# HISTORIC AND DESIGN REVIEW COMMISSION

**HDRC CASE NO:** 2015-254  
**ADDRESS:** 200 / 223 S ALAMO ST  
**LEGAL DESCRIPTION:** NCB 14016 BLK 9 LOT 14(0.082AC), 16(0.335AC), & S IRR 409.04 FT OF 15(0.36AC)  
**ZONING:** D HS RIO-3  
**CITY COUNCIL DIST.:** 1  
**LANDMARK:** Hilton Palacio de Rio Hotel  
**APPLICANT:** Robert Thrailkill  
**OWNER:** Zachary Corporation  
**TYPE OF WORK:** Exterior modifications  
**REQUEST:**

# HILTON PALACIO DEL RIO

HDRC SUBMITTAL FOR CONCEPTUAL APPROVAL

- |   |                                   |   |                  |

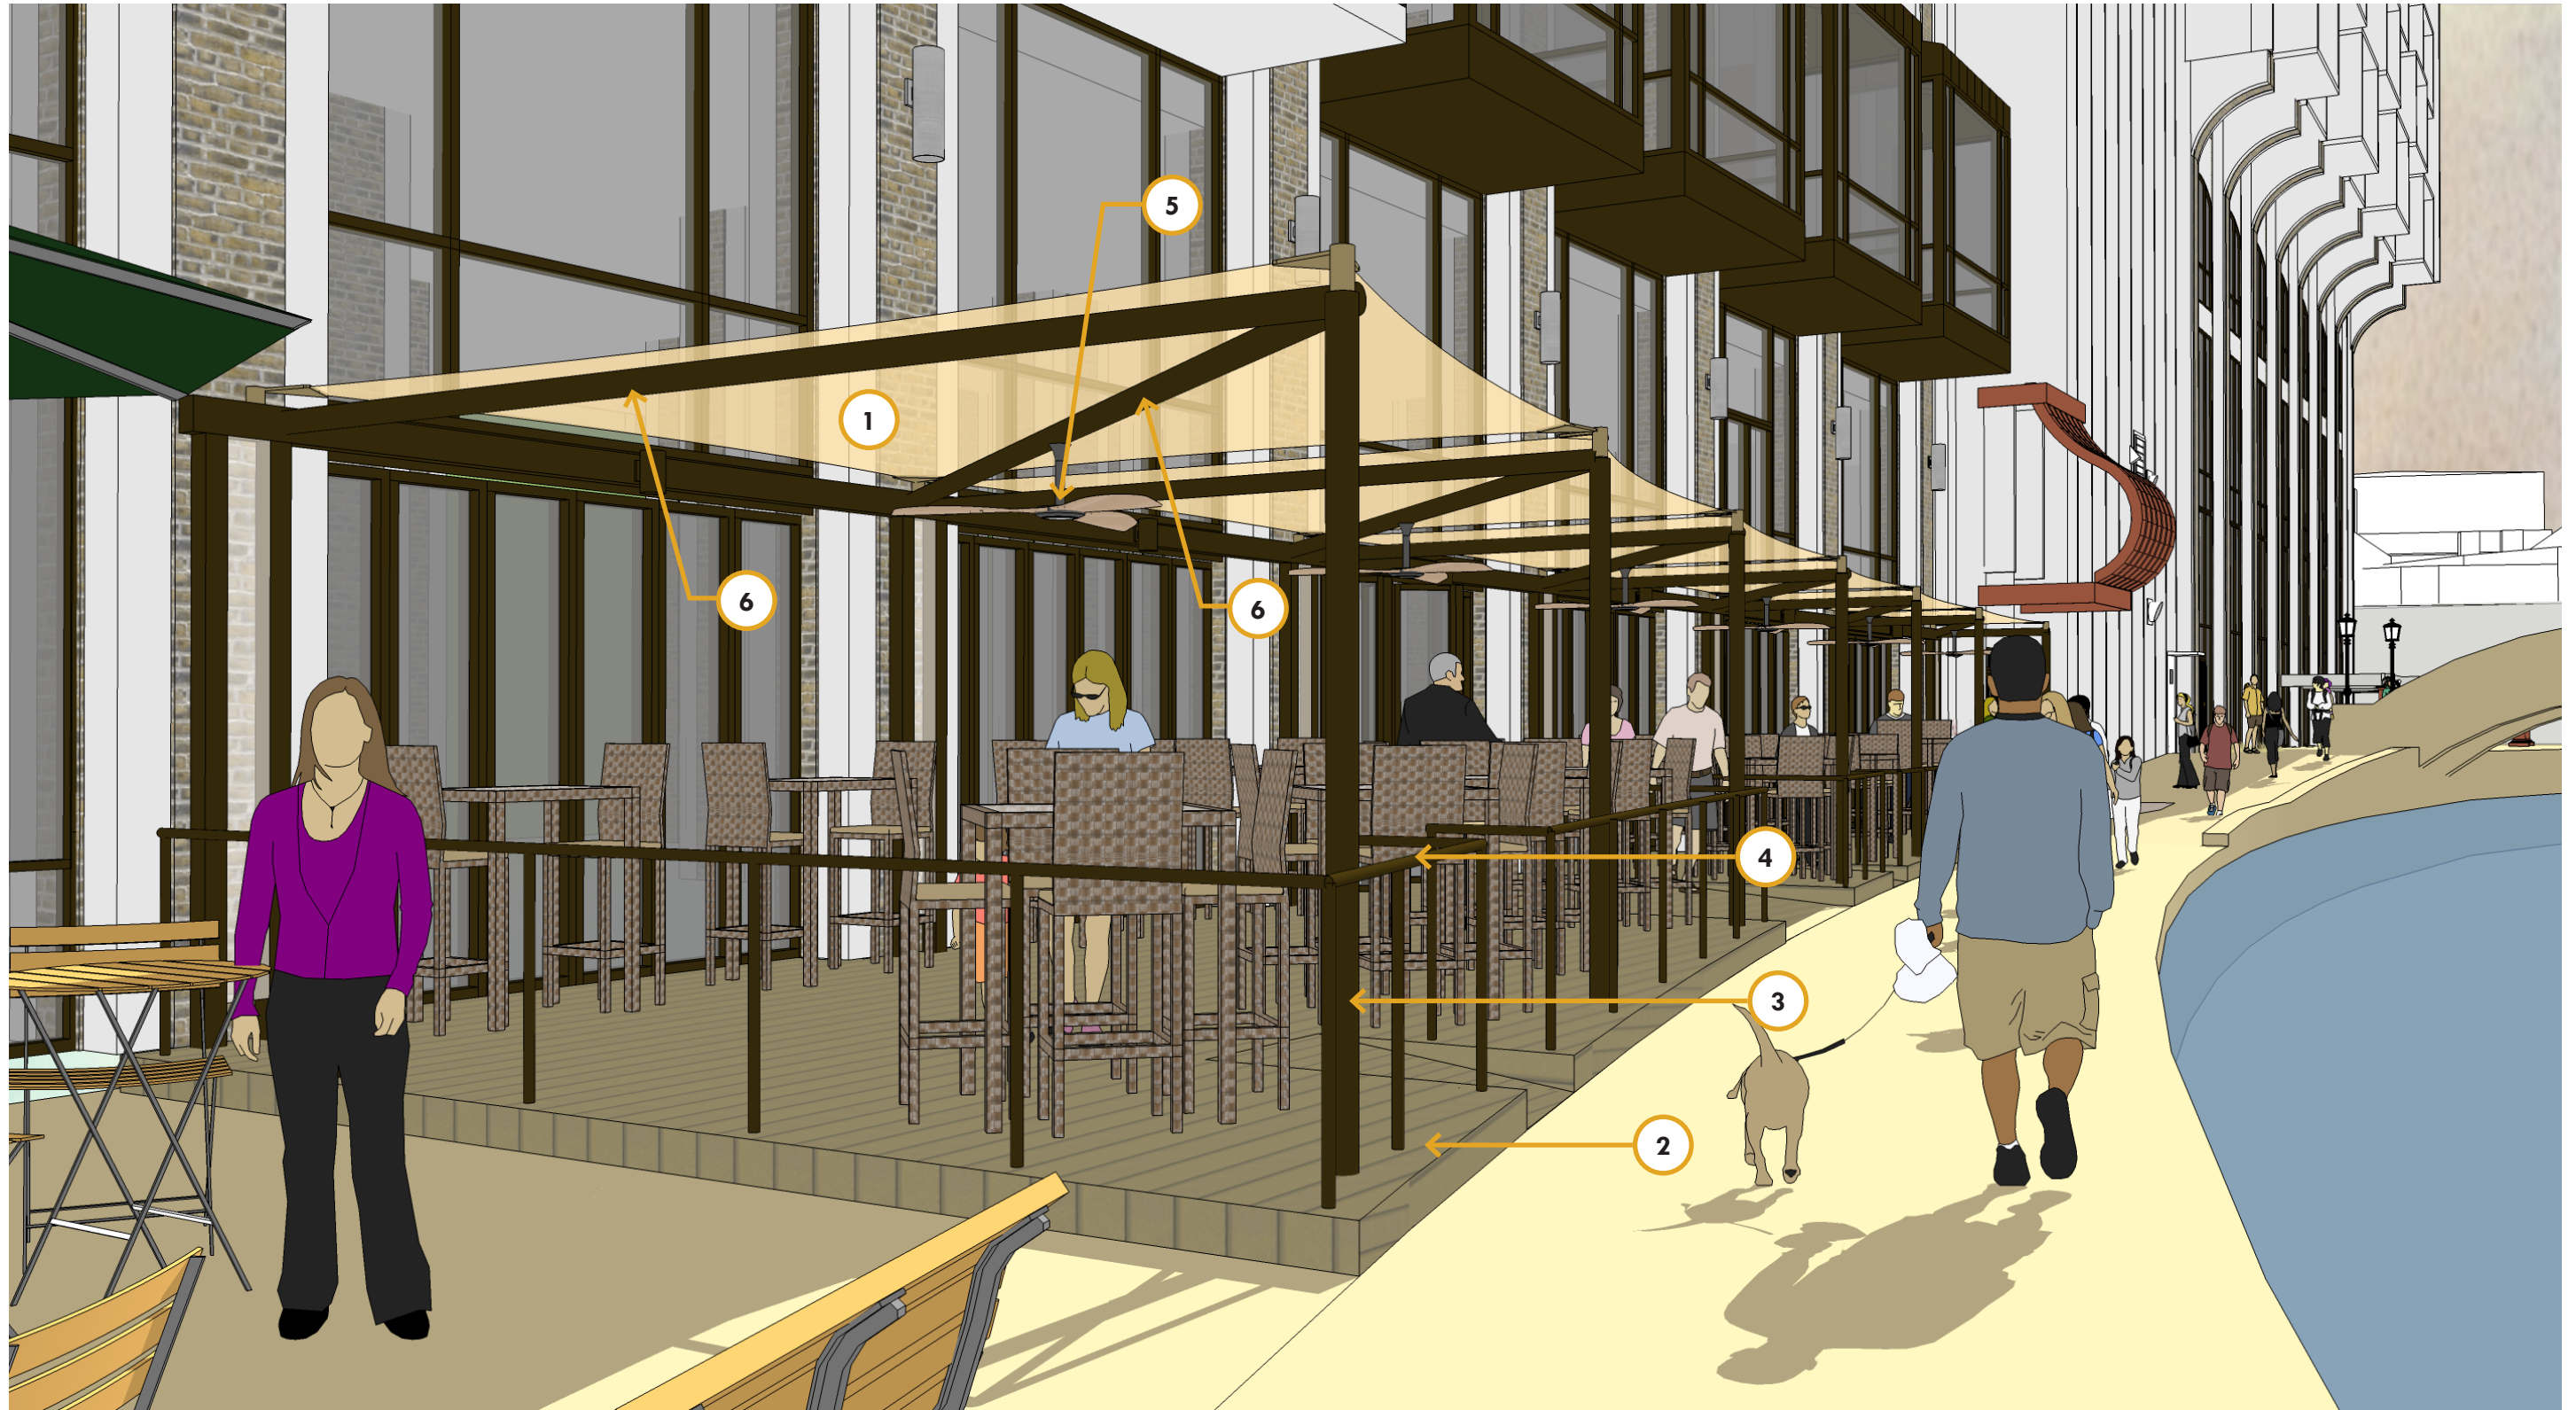
- c. The applicant has proposed a new outdoor canopy at the Riverwalk level that is to be composed of painted steel framing, painted railings, a fabric canopy and will feature ceiling fans for patron comfort. According to the UDC Section 35-674(g) regarding awnings, canopies and arcades, any awnings, canopy or arcade should be designed to accentuate the primary structure in form, proportions, materials, color and should include lighting that is incorporated into the design. The applicant's proposal is consistent with the UDC.

- d. Per the UDC Section 35-673(j)(1), site lighting shall be shielded by permanent attachments to light fixtures and for spaces adjacent to or visible from the San Antonio River should average ambient light levels of between one and three foot-candles with a minimum of 0.5 foot candles, should not produce light pollution greater than one half of one foot candle measured at any point ten feet beyond the property line and should feature a light temperature and color between 2500 K and 3500 K with a color rendition index (CRI) or eighty or higher. The applicant is responsible for complying with this section of the UDC.

- i. That the applicant provide more information regarding the proposed canopy lighting including specific materials, details and a lighting scheme.
- ii. That the applicant provide more information regarding the proposed concrete deck's final finish.
